Artist Inquiries for Public Art for the Interior Library Entry Hall as of 2/4/2015 at 9:30 a.m.

FIG. 307.2
LIMITS OF PROTRUDING OBJECTS

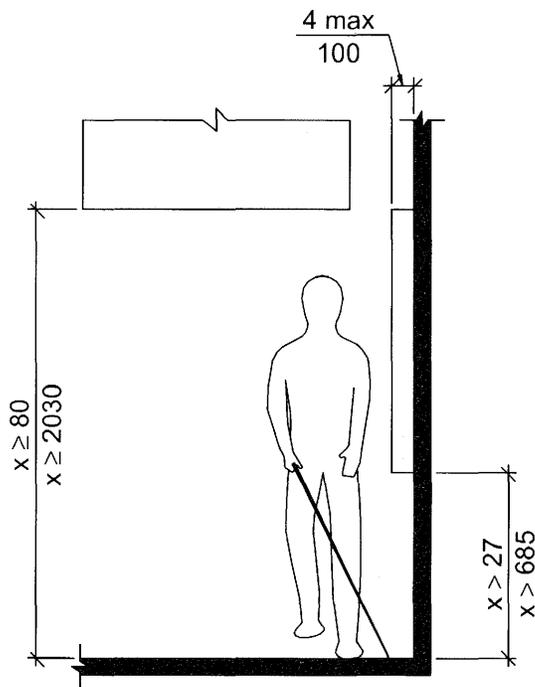
As they are not attached to the walls how would this freestanding installation relate to the ADA rules?

There are a number of ways to address this question or issue. We have plenty of exit clearance width, so that really isn't an issue. We cannot create a hazard for any patrons with disabilities. In the case of items protruding more than 4" out from the wall surface and at a height above 27" from the floor, the concern is primarily with blind or visually impaired people possibly running into the object and getting hurt. The 27" height is key here because that is deemed as part of the "detection zone". If an object meets the floor - like a book display unit, for example - it can be any (reasonable) size and a visually impaired person will be able to use their cane to "detect" its presence. Objects that protrude greater than 4" from the wall and do not extend to the floor (or into the 27" zone) are not likely to be struck (detected) by a person's cane, therefore they pose a greater risk and are not allowed.

I've attached the page from the code that might help to graphically explain the criteria.

We have to address this frequently with our architectural solutions and often incorporate an element at the floor plane: a fixed bench, built-in display, slightly raised decorative gravel bed, or textured, non-walkable surface, etc. We can clarify further at the pre-proposal meeting if needed.
